UNITED STATES PATENT AND TRADEMARK OFFICE

10/586,898

Office Action Summary	Application No. 10/586,898	Applicant(s) HAECKH ET AL.	
	Examiner JORGE PEREIRO	Art Unit 3749

DETAILED ACTION

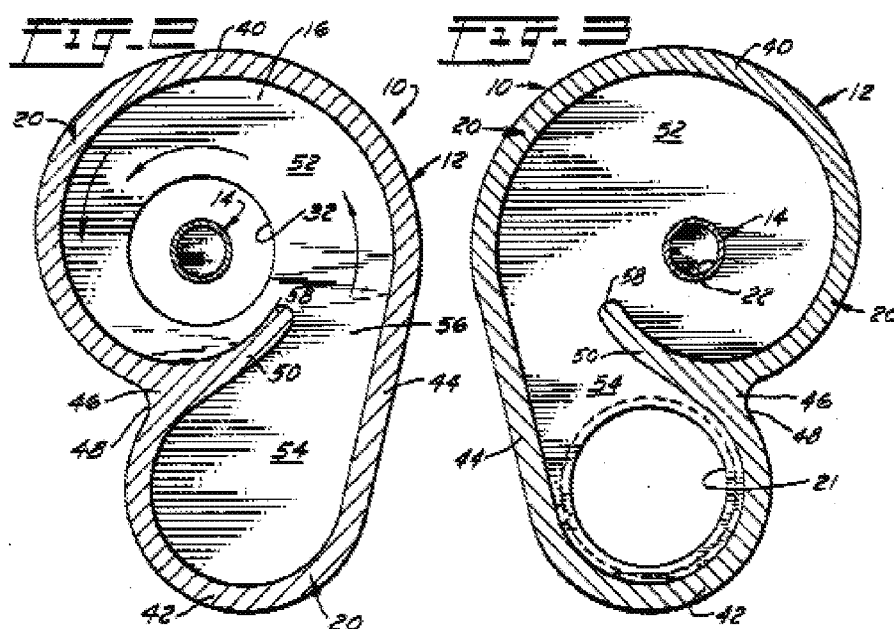
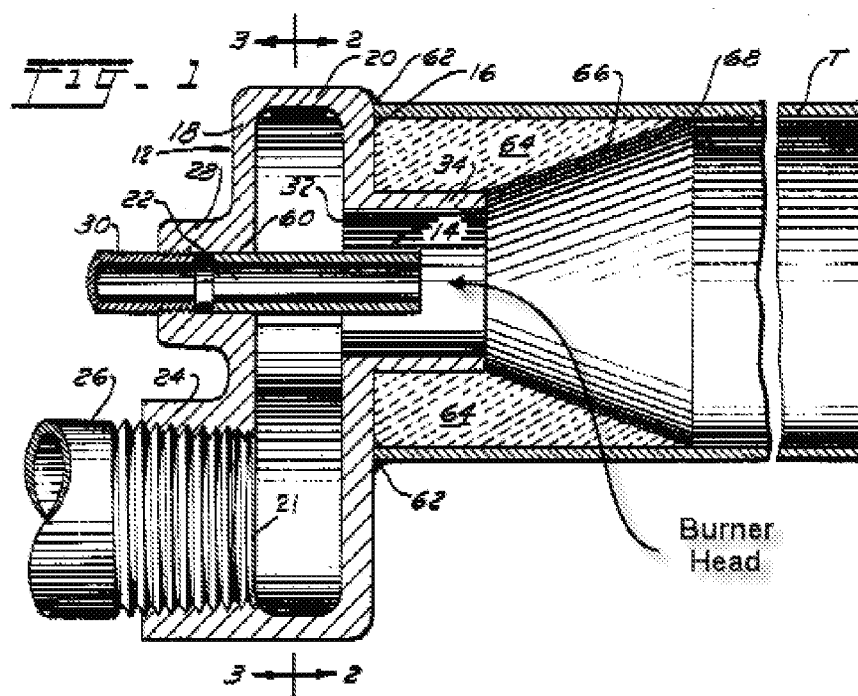
10. In re claim 18, with reference to figures 1-3 below, Keating discloses an externally mixing burner (10) having a burner head (see figure 1 below), at least one combustion gas tube (14) and at least one tube for an oxygen-containing gas (24), wherein the burner head has outlet openings out of the combustion gas tube and out of the tube for the oxygen-containing gas (see figure 1 below), wherein gas inlet lines (30, 26) are provided for a combustion gas and for the oxygen-containing gas, each being connected to a source for combustion gas and/or for oxygen-containing gas (inherent), respectively, and wherein at least one gas inlet line (26) opens eccentrically into a swirl

chamber (52) which is arranged between the gas inlet line and the combustion gas tube and/or between the gas inlet line and the tube for oxygen-containing gas (34).

11. In re claim 22, with reference to figures 1 and 2 above, Keating discloses wherein the swirl chamber (52) has a circular cross-section in a section perpendicular to a longitudinal axis of the combustion gas tube (14).

12. In re claim 23, reference to figures 1 and 2 above, Keating discloses wherein the gas inlet line (26) opens tangentially (56) into the swirl chamber (52).

15. In re claim 35, with reference to figures 1-3 above, Keating discloses a burner (10), comprising: a combustion gas tube (14); a first gas inlet line (30) coupled to the combustion gas tube; an oxygen-containing gas tube(34); a second gas inlet line (26) coupled to the oxygen-containing gas tube; and a swirl chamber (52), wherein the swirl chamber is disposed between either the first gas inlet line and the combustion gas tube or between the second gas inlet line and the oxygen-containing gas tube.

16. In re claim 37, with reference to figures 1-3 above, Keating discloses a method for operating a burner (10), comprising the steps of: controlling a flow of a combustion

gas (via gas supply line 30) to a combustion gas tube (14); controlling a flow of an oxygen-containing gas (via gas supply line 26) to an oxygen-containing gas tube (24); swirling the combustion gas or the oxygen-containing gas in a swirl chamber (52); and supplying the combustion gas and the oxygen-containing gas to the burner (inherent).

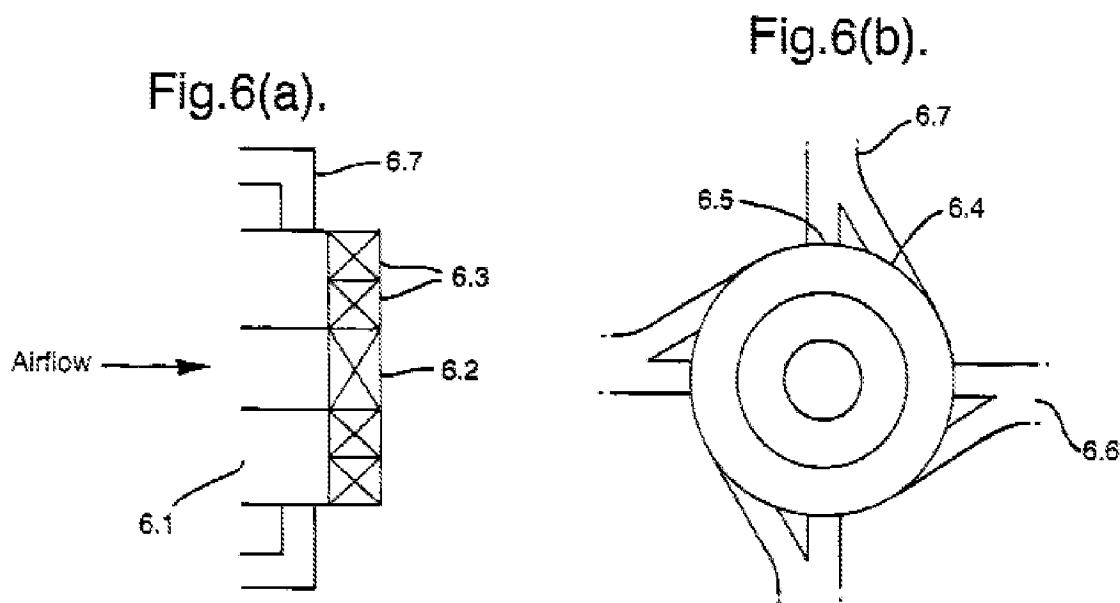
22. Nonetheless, with reference to figures 6(a) and 6(b) below, Brundish discloses a fuel injector including an air flow conduit (6.1), a combustion fuel flow conduit (not shown) and swirlers (6.2, 6.3) wherein at least one of the gas inlet lines (6.7) is divided into two lines (6.4, 6.5) upstream of a swirl chamber (6.3), wherein one of these lines (6.5) opens directly into the combustion gas tube and/or into the tube for oxygen-containing gas.

39. Nonetheless, with reference to figures 6(a) and 6(b) of Brundish above, Brundish discloses gas inlet lines that split into a first and a second portion that couple to the gas tube and have control means (see column 5, lines 16-22 and column 7, lines 24-35).

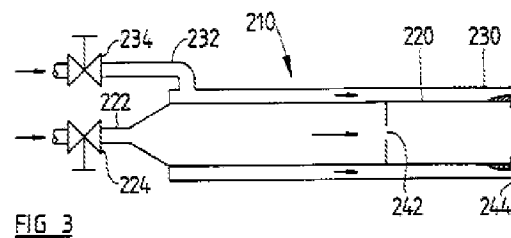
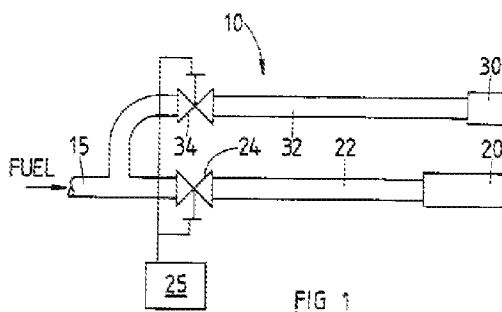
47. Nonetheless, with reference to figures 1 and 3 below, Luxton discloses a burner configuration including means to control the proportions of fuel flow wherein a quantity of combustion gas and oxygen-containing gas supplied to the burner per unit of time is controlled and/or regulated, wherein the combustion gas and the oxygen-containing gas are sent through valves (224, 234) wherein a degree of opening of the valves is controlled or regulated such that the burner produces a flame having a desired shape which is adjustable via a control and/or regulating unit (25). (See column 3, lines 45-50 and column 4, lines 30-52).
